SUBDIVISION AUTHORITY AGENDA MEETING NO. 41

File No. LDA13-0272

RE: Tentative plan of subdivision to create 43 single detached residential lot and 44 row housing lots, from Lot 4, Block 1, Plan 212 2367, Lot 11, Block 16, Plan 122 0171, Lot 4, Block C, Plan 132 0859 and Block C, Plan 2887 AQ located south of 178 Avenue NW and west of 66 Street NW;
CRYSTALLINA NERA EAST

This is the first change request to LDA13-0272 which reconfigures the lotting by reducing the number of single detached lots from 83 to 43, removes the semi-detached lots, removes the multi-unit housing lot, and introduces 44 row housing lots. In addition, the radii of the cul-de-sacs off of Crystallina Nera Drive are being updated to current standards. No construction has occurred since the original approval on April 10, 2014.

SUBDIVISION CONDITIONS OF APPROVAL MAP

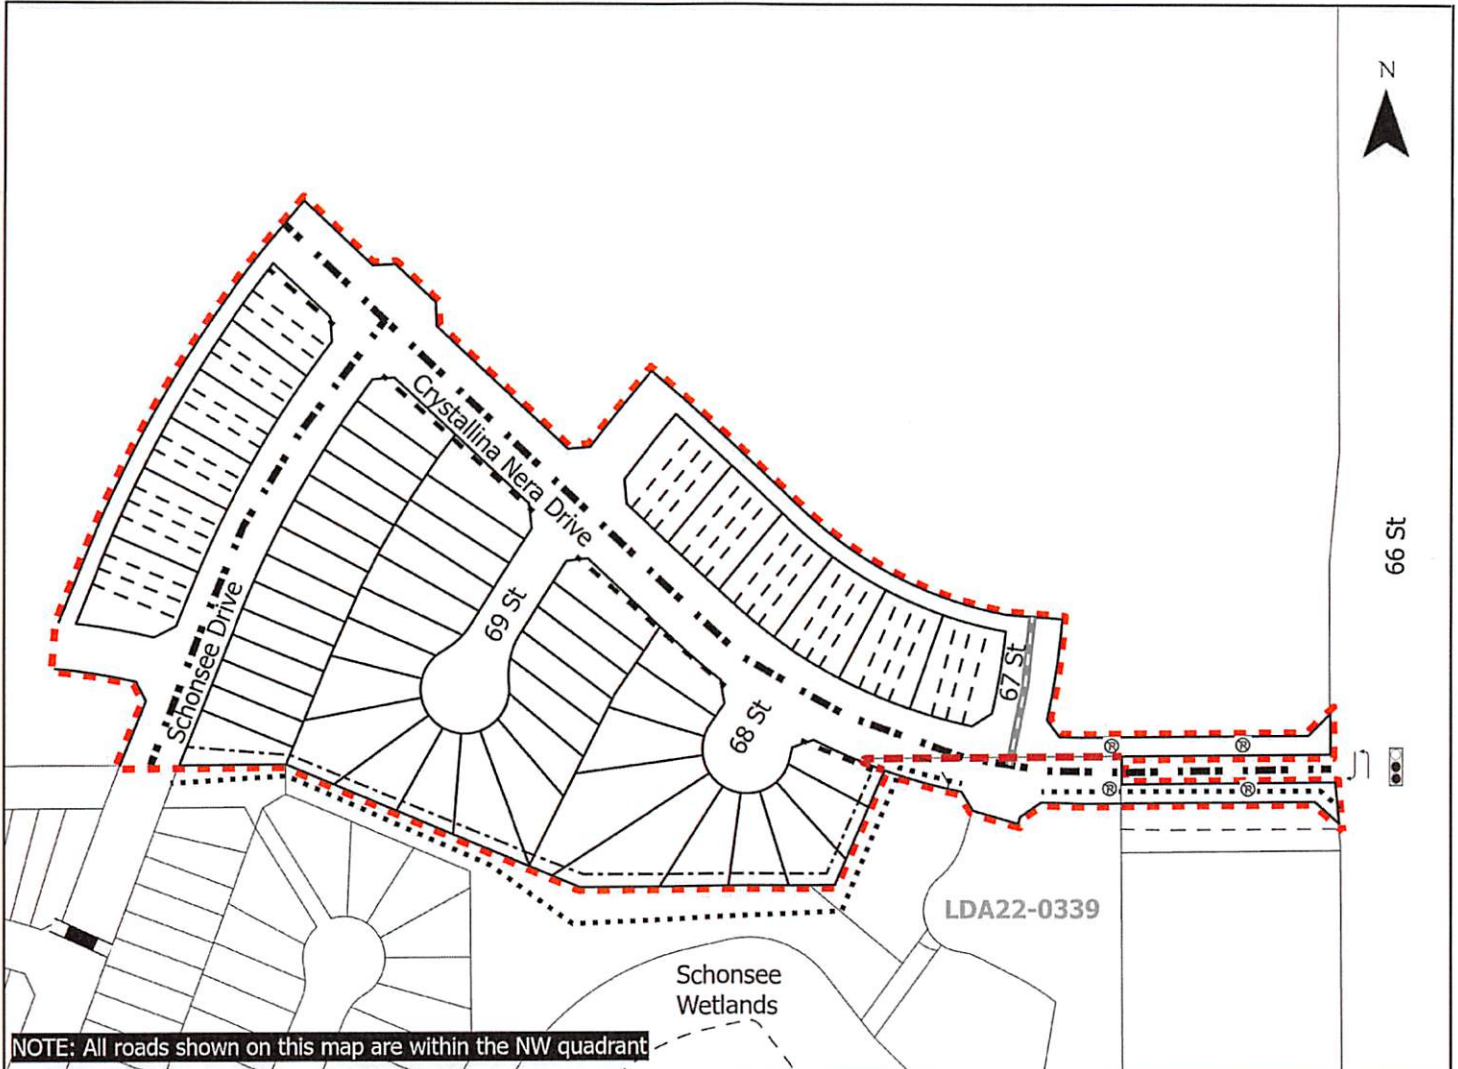
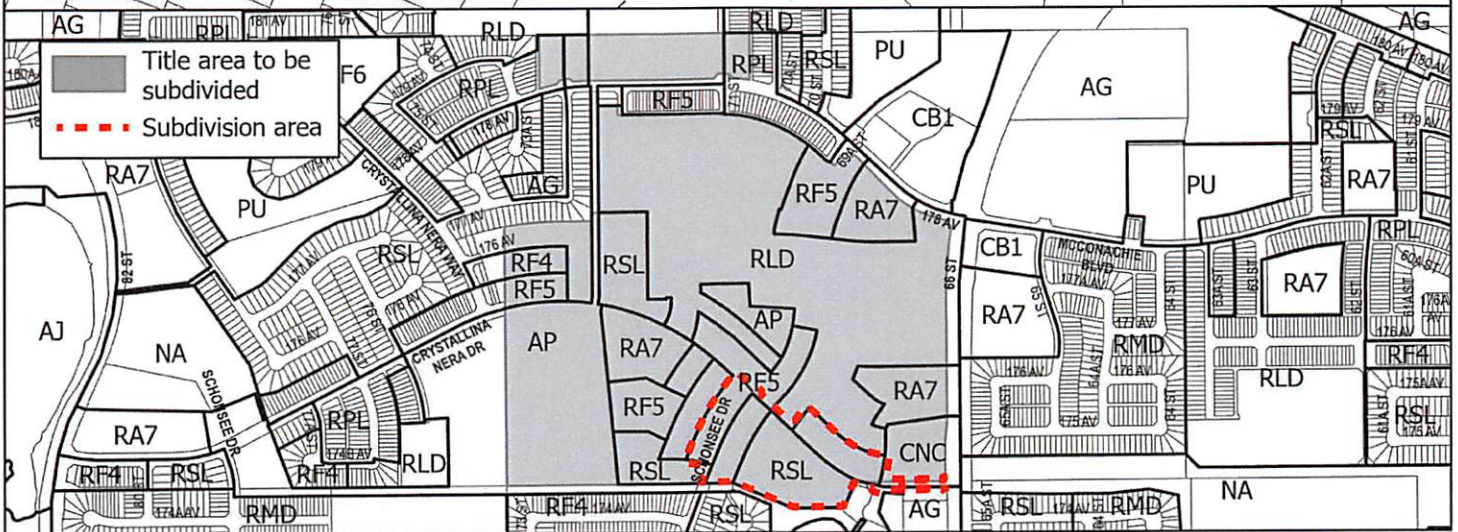
3. that the subdivision boundary be amended to exclude a portion of Crystallina Drive NW that is to be dedicated with subdivision LDA22-0339 as shown on the "Conditions of Approval" map, Enclosure I;

9. that the owner construct Schonsee Drive NW to a collector roadway standard, to an approved Complete Streets cross-section, from the existing terminus at the south subdivision boundary to Crystallina Drive NW, to the satisfaction of Subdivision and Development Coordination, as shown on the "Conditions of Approval" map, Enclosure I;

10. that the owner construct 67 Street NW to an approved Complete Streets cross-section, to ensure that two driving lanes are maintained at all times to accommodate higher volumes of traffic, to the satisfaction of Subdivision and Development Coordination, as shown on the "Conditions of Approval" map, Enclosure I;

13. that the owner provide a zebra marked crosswalk and pedestrian signage at the mid-block crossing on Schonsee Drive NW, to the satisfaction of Subdivision and Development Coordination, as shown on the "Conditions of Approval" map, Enclosure I;

15. that the owner construct all fences wholly on privately-owned land, to the satisfaction of Subdivision and Development Coordination, as shown on the "Conditions of Approval" map, Enclosure I; and

SUBDIVISION CONDITIONS OF APPROVAL MAP

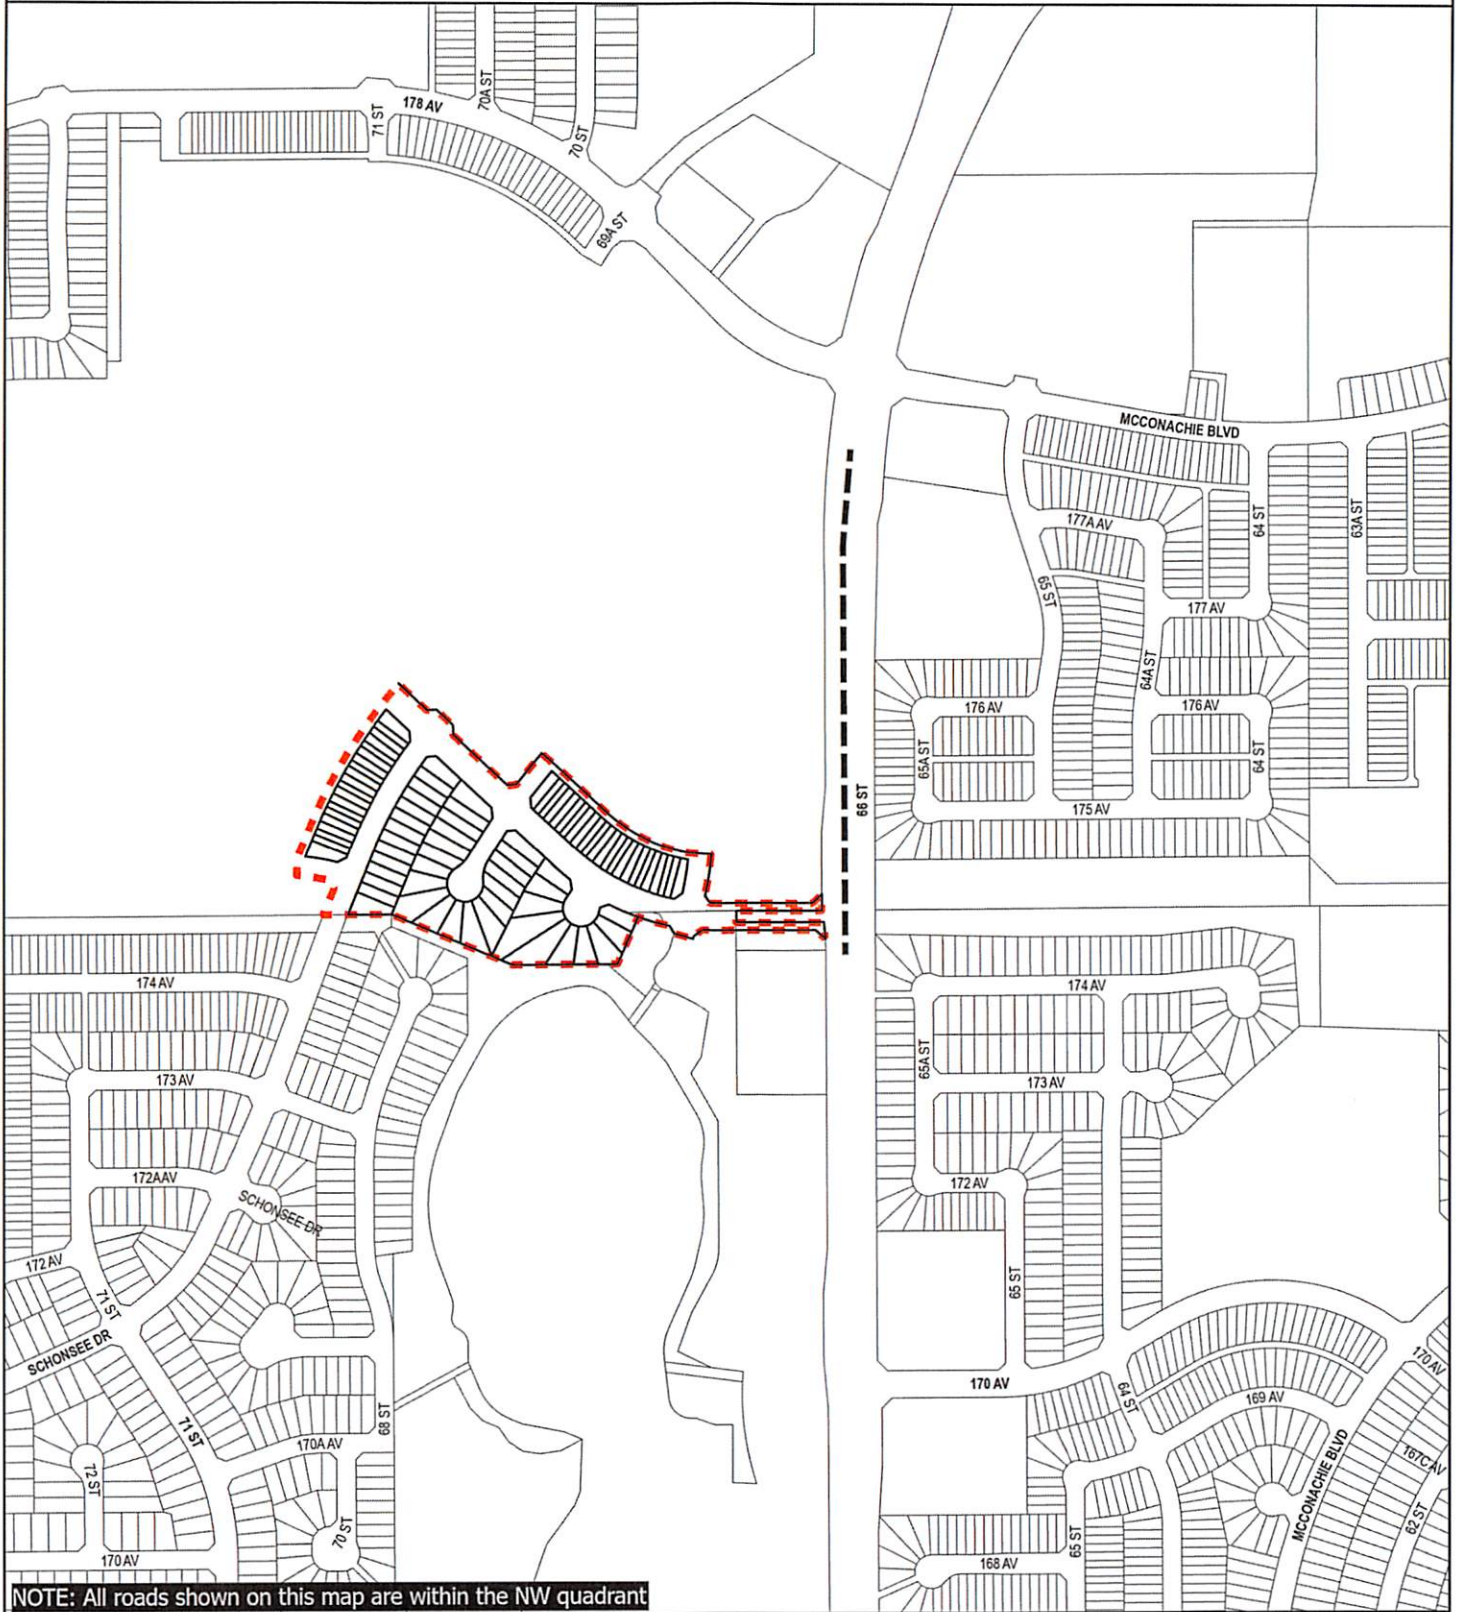
7. that the owner constructs 66 Street NW to a 4 lane arterial roadway standard to an approved Concept Plan, from Crystallina Nera Drive NW to tie into the existing 4 lane section south of 178 Avenue NW/McConachie Boulevard NW, including channelization, accesses, intersections, turn bays, bus stop & amenity pads, shared use paths, sidewalks, lighting, landscaping, paint line marking modifications, and any transitional improvements, to the satisfaction of Subdivision and Development Coordination, as shown on the "Conditions of Approval" map, Enclosure II;

Tentative Plan of Subdivision of
 Condominium Plan 942 1475
 11723/11725 - 125 St. NW
 Rev.3 Adjusted garage offset

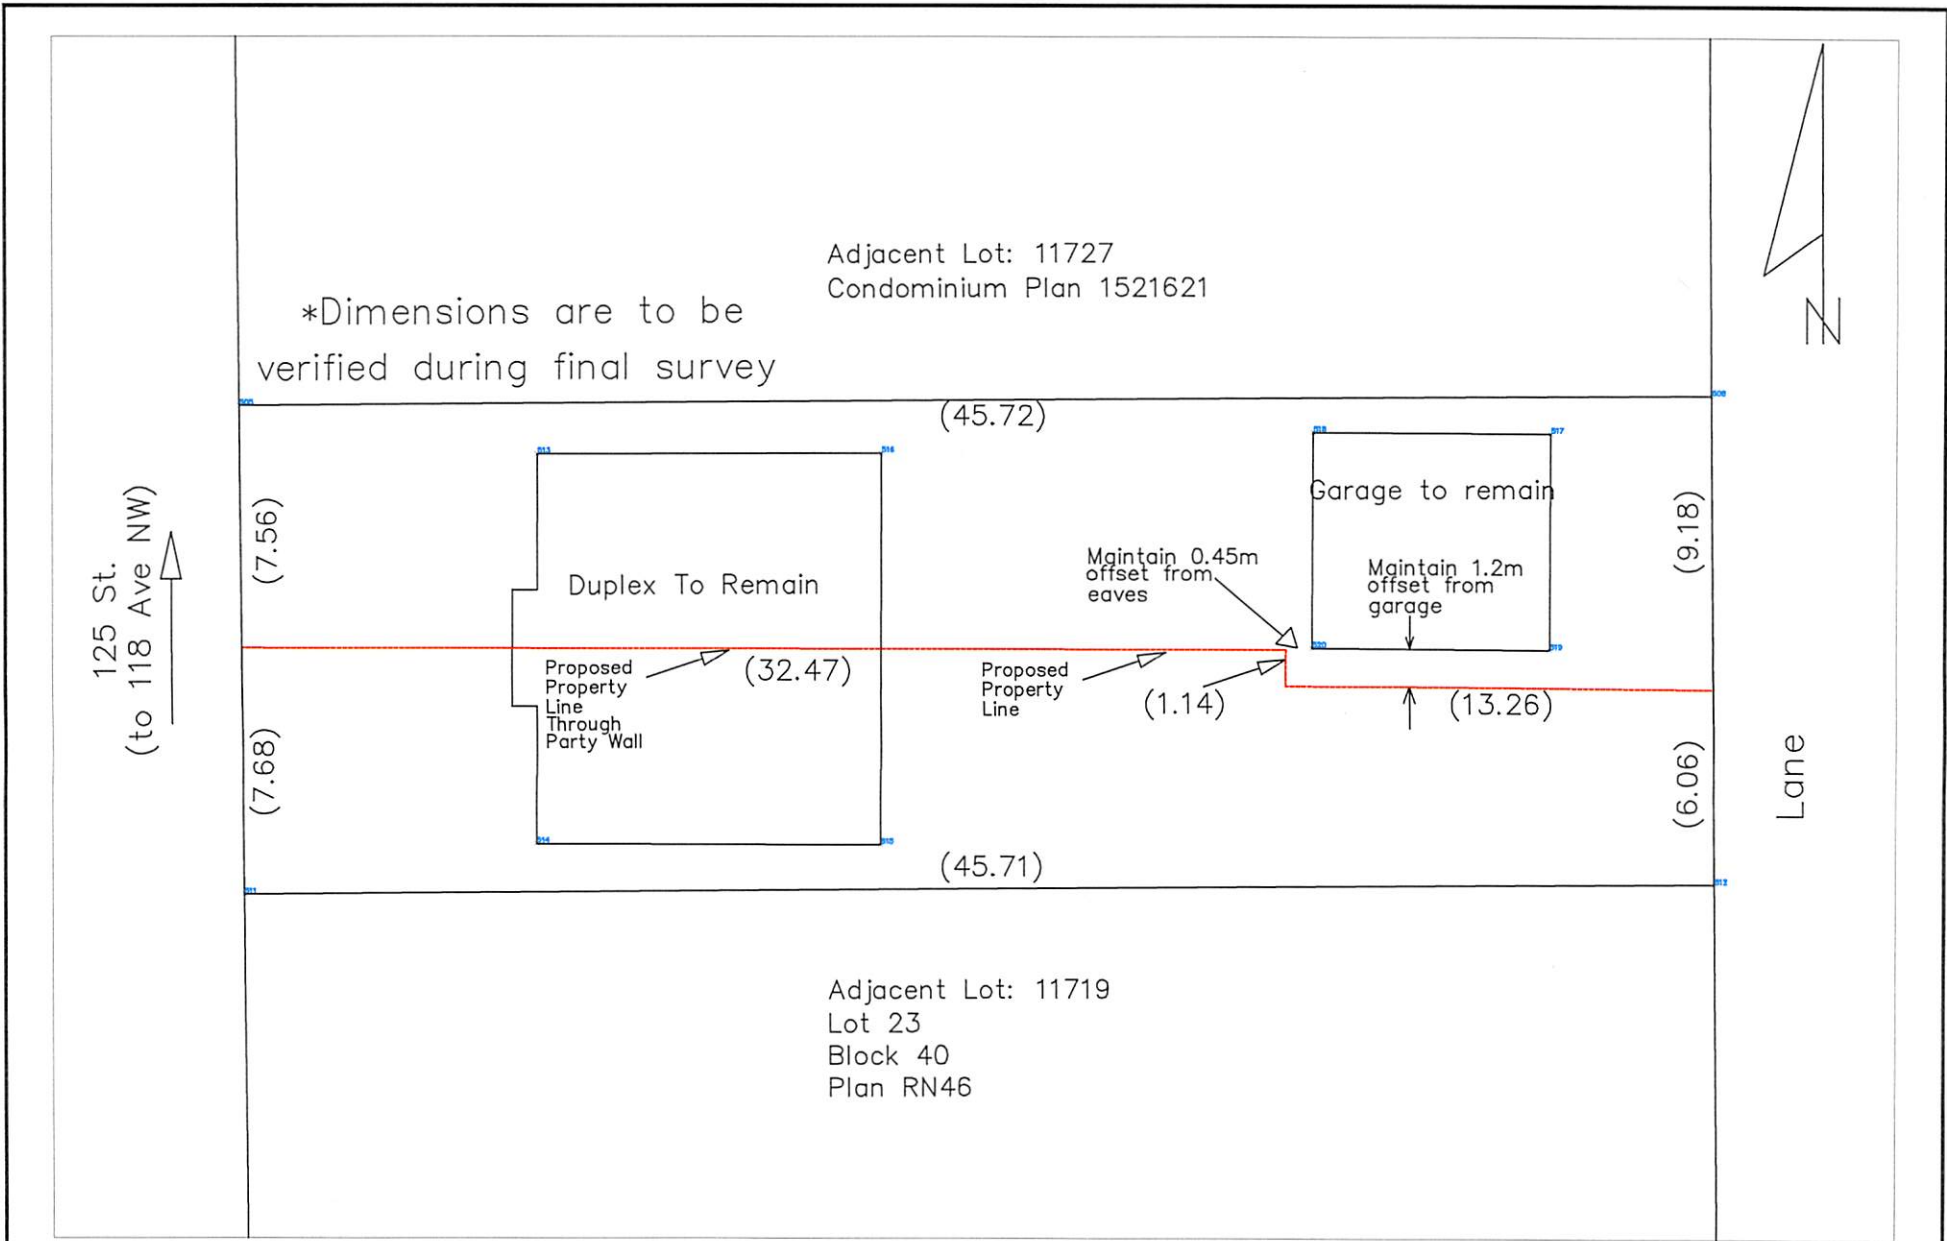
1. that the owner make satisfactory arrangements with EPCOR Water Services Inc. and EPCOR Drainage Services for the provision of separate services (water and sanitary) to each half of the semi-detached dwelling. However, for buildings constructed prior to 1992 there is an option to retain the existing services (please refer to Enclosure II);

2. that subject to Condition #1, the owner make arrangements to ensure that the private sewer services, storm water services, and water services for each unit are connected separately outside of the building, to the satisfaction of EPCOR Drainage Services and EPCOR Water Services Inc. If the services are connected separately outside of the building, the owner must ensure that they abide by the servicing conditions for buildings constructed prior to 1992 (please refer to Enclosure II);

4. that the final plan of survey shall conform to the attached revised tentative plan; and
5. that the owner pay all outstanding property taxes prior to the endorsement of the plan of survey.
